AMENDMENTS TO THE DRAWINGS

REMARKS

Objections to the Drawings and Rejections Under 35 U.S.C. § 112

Fig. 1A

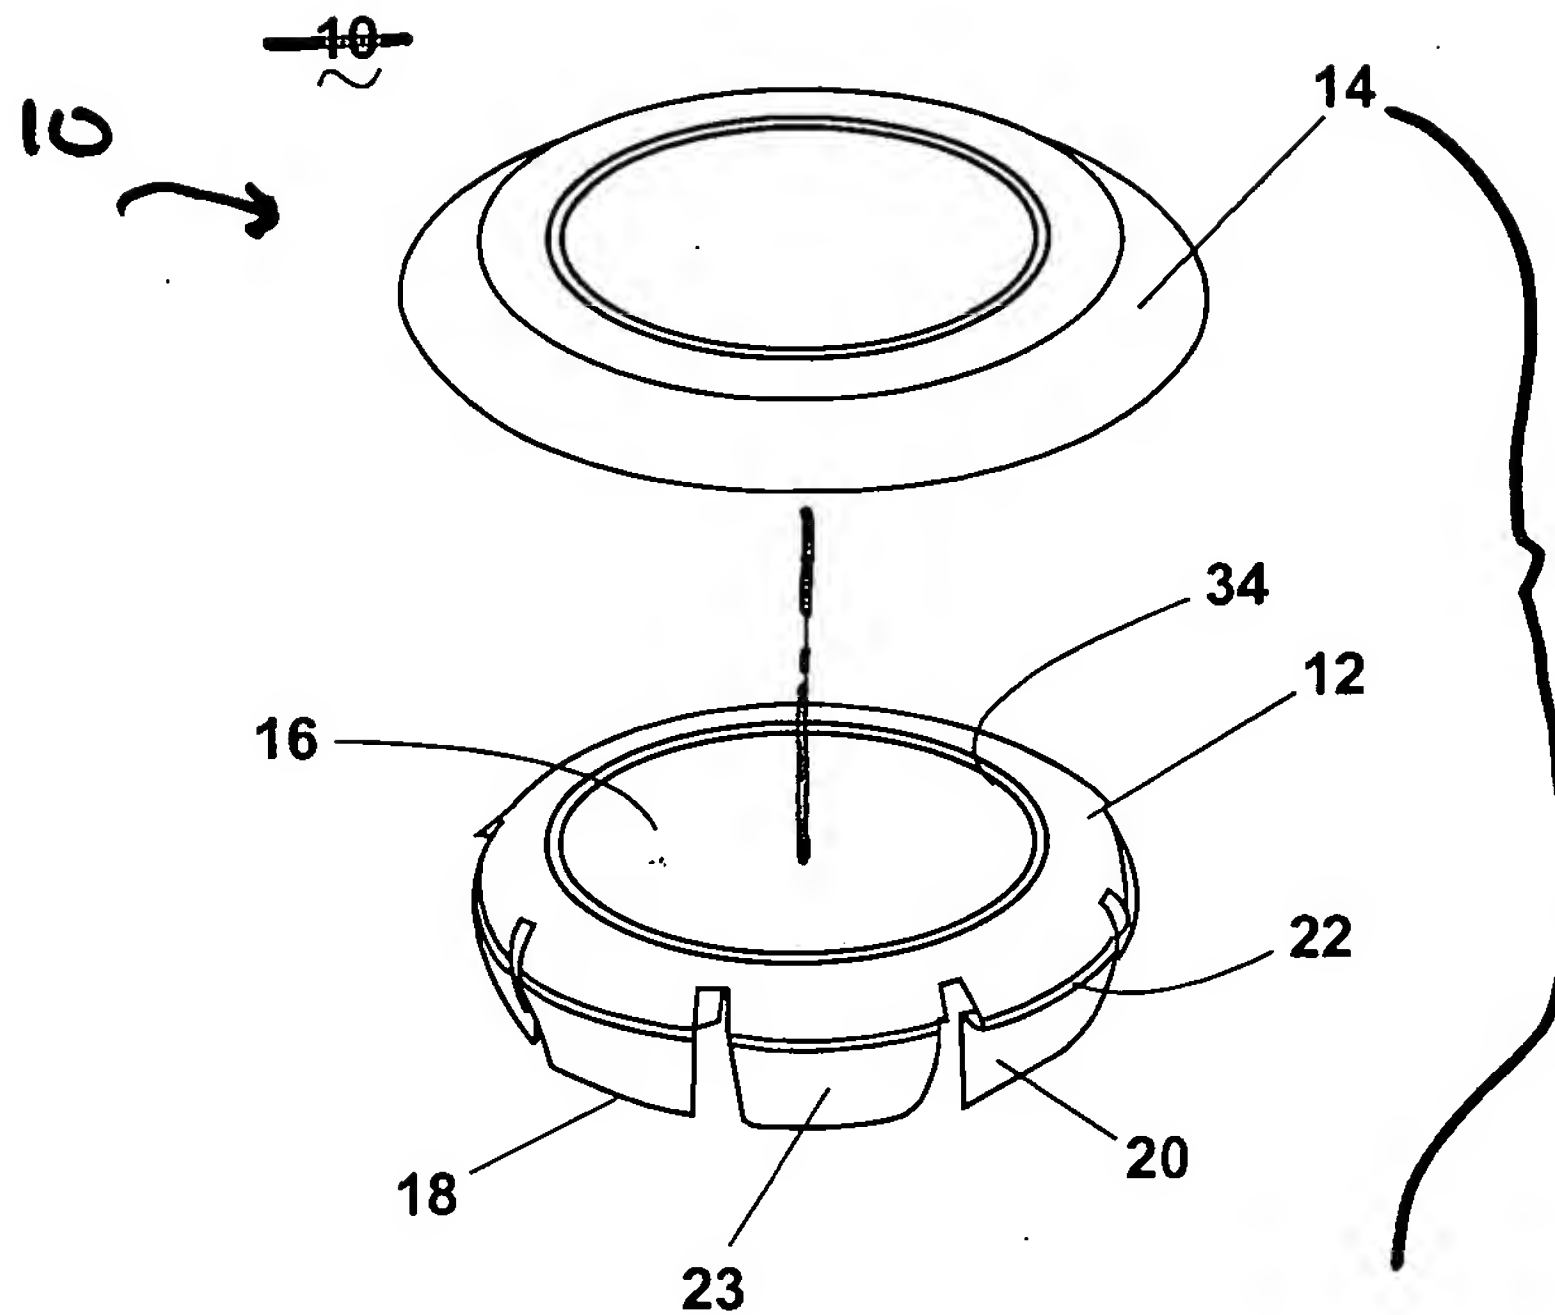
In the Office Action (pages 3-6), the Examiner objected to Figures 1A, 1B, 2, 3B, 4B, 5A, 5B, 6, 7, and 8 for various informalities including a failure to show every feature of the invention as specified in the claims. In addition, the Examiner rejected claims 1-4 and 10 under 35 U.S.C. §112, second paragraph, as being indefinite for failing to particularly point out and distinctly claim the subject matter which applicant regards as the invention. The objections and rejections appear to be inter-related to the extent that they stem from the absence of a panel member in the drawings. In response, Applicants have amended the above-referenced Figures to address each of the informalities cited by the Examiner including amending Figure 8 to show the panel member and its relation to the physical barrier of claims 1-4 and 10. In light of the foregoing amendments, Applicants believe the objections and rejections to be moot and respectfully request withdrawal of the same.

The Examiner further objected to paragraphs [0019] – [0021] for an alleged informality in referencing the Figures. Specifically, the objection to paragraph [0019], being taken here as exemplary, states that “Paragraph [0019] is incorrect because only the plastic carrier (12) of Fig. 1A is shown in Fig. 6, not the entire physical barrier of Fig. 1B ...” (Office Action, page 6). Applicants disagree.

At the outset, Figure 1A illustrates an exploded view of physical barrier 12 including a patch 14 and a carrier 12. Figure 1B illustrates an assembled view of the physical barrier of Figure 1A. Paragraph [0019] as originally drafted in the specification states that, “FIG. 6 shows a cross-sectional view of the physical barrier of FIG. 1B according to another embodiment of the present invention.” The Examiner contends that this description is incorrect because Figure 6 only shows the plastic carrier (12) of Figure 1A. Applicants respectfully submit that the Examiner has misconstrued what is shown by Figure 6. Applicants draw the Examiner’s attention to Figure 6 and note that, consistent with the original language of paragraph [0019], Figure 6 clearly shows a cross-sectional view of the entire physical barrier including the patch 14 and the carrier 12. As previously stated, the argument as set forth above with respect to paragraph [0019] was exemplary, and is therefore equally applicable to paragraphs [0020] and [0021]. Accordingly, the objections with respect to paragraphs [0019] – [0021] should be withdrawn.

Applicants have amended Figures 1A, 1B, 2, 3B, 4B, 5A, 5B, 6, 7, and 8 to correct inadvertent formatting errors and to address the Examiner's objections. No new matter has been added. In addition, drawing headings have been added to each drawing sheet. Therefore, Applicants are submitting replacement sheets for all six drawings sheets.
